Access Compliance Report

Public Rights-of-Way

Intersection ID: 3233	Main Street: HERITAGE_HILLS_LN	Cross Street: PROSPERITY_CHURCH_RD	Location: SW
ADA ID: E0FA3EB4D63C	Ramp Type: Perp	Initial Pass/Fail: Fail	Overall Compliance: No
Severity Score: 22.5			
Codes/Mitigation Info/Possible Solution		Field Measurements/Component Compliance

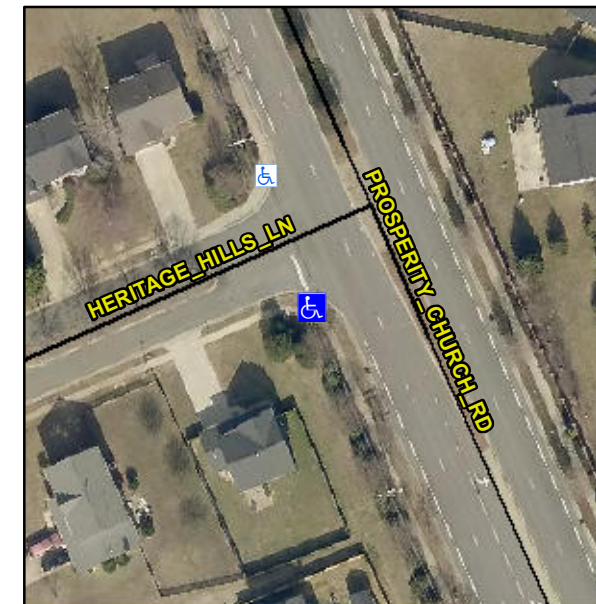
Not Found, R304.5.1, R304.2.2, R304.5.3

Compliance	Description	Data	Compliance	Description	Data
N/A	Ramp Length (in)	85.0	No	Ramp Slope (%)	8.4
No	Ramp Width (in)	36.0	No	Ramp XSlope (%)	3.9
N/A	Flare Type LT	N/A	N/A	Flare Type RT	N/A
N/A	Flare Slope LT (%)	N/A	N/A	Flare Slope RT (%)	N/A
N/A	Flare Traversable LT?	N/A	N/A	Flare Traversable RT?	N/A
N/A	Landing Length (in)	N/A	N/A	DWS Provided?	N/A
N/A	Landing Width (in)	N/A	N/A	DWS Contrast?	N/A
N/A	Landing Slope (%)	N/A	N/A	DWS Length (in)	N/A
N/A	Landing X Slope (%)	N/A	N/A	DWS Full Width?	N/A
N/A	Landing Curb? (Y/N)	N/A	N/A	DWS Offset (in)	N/A
N/A	Shared Landing?	N/A			
N/A	Gutter Ponding?	N/A	N/A	Gutter Slope (%)	N/A
N/A	Gutter Lip Ht (in)	N/A	N/A	Gutter X Slope (%)	N/A
N/A	Painted X Walk1?	No	N/A	Painted X Walk2?	N/A
	X Walk 1 Direction	To N		X Walk 2 Direction	N/A
N/A	X Walk 1 Width (in)	N/A	N/A	X Walk 2 Width (in)	N/A
	X Walk 1 Slope (%)	1.9		X Walk 2 Slope (%)	N/A
	X Walk 1 X Slope (%)	6.7		X Walk 2 X Slope (%)	N/A

Remove & Replace Entire Ramp.
